Access Compliance Report

Public Rights-of-Way

(Pedestrian Signals)

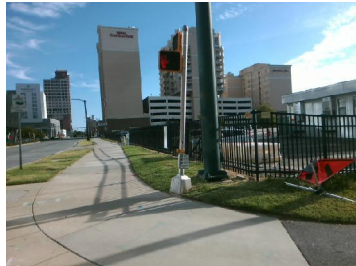
PROW/ADA: TMUTCD 4e.08, R404.2, R404.3, R406.2

Compliance	Description	Data	Compliance	Description	Data
	Button Count	Button2	N/A	Distant to Additional Button (in)	N/A
	Additional Button Present?	N/A		Additional Button ID	N/A
N/A	Signal Buttons Required?	N/A	N/A	Additional Ped Posts Required	N/A
	How Many Ped Street Xings?	2		Located In An Island/Median?	No
N/A	B 1 Sign Present?	Yes	N/A	B 2 Sign Present?	Yes
Yes	B 1 Sign Purpose?	Yes	Yes	B 2 Sign Purpose?	Yes
Yes	B 1 Sign Lettering & Contrast?	Yes	Yes	B 2 Sign Lettering & Contrast?	Yes
Yes	B 1 Parallel To XWalk?	Yes	Yes	B 2 Parallel To XWalk?	Yes
Yes	B 1 PAR to Button?	Yes	Yes	B 2 PAR to Button?	Yes
Yes	B 1 PAR to XWalk?	Yes	Yes	B 2 PAR to XWalk?	Yes
Yes	B 1 Clear Floor Space?	Yes	Yes	B 2 Clear Floor Space?	Yes
N/A	B 1 FWD Approach?	Yes	N/A	B 2 FWD Approach?	Yes
N/A	B 1 FWD Approach Constrained?	No	N/A	B 2 FWD Approach Constrained?	No
No	B 1 FWD Approach Reach (in)	9.0	No	B 2 FWD Approach Reach (in)	7.0

N/A	B 1 FWD Approach Width (in)	N/A	N/A	B 2 FWD Approach Width (in)	N/A
N/A	B 1 FWD Approach Obstruction?	Yes	N/A	B 2 FWD Approach Obstruction?	Yes
N/A	B 1 FWD Approach Obstruction Dist (in)	2.0	N/A	B 2 FWD Approach ObstructionDist (in)	5.0
N/A	B 1 PARA Approach?	Yes	N/A	B 2 PARA Approach?	Yes
N/A	B 1 PARA Approach Constrained?	No	N/A	B 2 PARA Approach Constrained?	No
Yes	B 1 PARA Approach Reach (in)	5.0	Yes	B 2 PARA Approach Reach (in)	5.0
N/A	B 1 PARA Approach Width (in)	5.0	N/A	B 2 PARA Approach Width (in)	N/A
N/A	B 1 PARA Approach Obstruction?	Yes	N/A	B 2 PARA Approach Obstruction?	Yes
N/A	B 1 PARA Approach Obstruction Dist (in)	5.0	N/A	B 2 PARA Approach ObstructionDist (in)	5.0
No	B 1 Clear Floor Space Slope (%)	10.3	Yes	B 2 Clear Floor Space Slope (%)	2.1
Yes	B 1 Clear Floor Space XSlope (%)	1.5	Yes	B 2 Clear Floor Space XSlope (%)	0.1
N/A	B 1 PAR Slope (%)	7.2	N/A	B 2 PAR Slope (%)	3.9
Yes	B 1 Height (in)	36.0	Yes	B 2 Height (in)	36.0

Yes	B 1 Clear Xing Direction?	ClearlyMarked	Yes	B 2 Clear Xing Direction?	ClearlyMarked
	B 1 Crossing Direction	To NW		B 2 Crossing Direction	To SW
Yes	B 1 DistanceTo XWalk (in)	0.0	Yes	B 2 DistanceTo XWalk (in)	10.0
No	B 1 DistanceTo Curb (in)	222.0	No	B 2 DistanceTo Curb (in)	240.0
Yes	B 1 Diameter (in)	2.0	Yes	B 2 Diameter (in)	2.0

Possible Solutions: Replace Signal Push Button With APS Button on New Post. Remove & Relocate Sign.
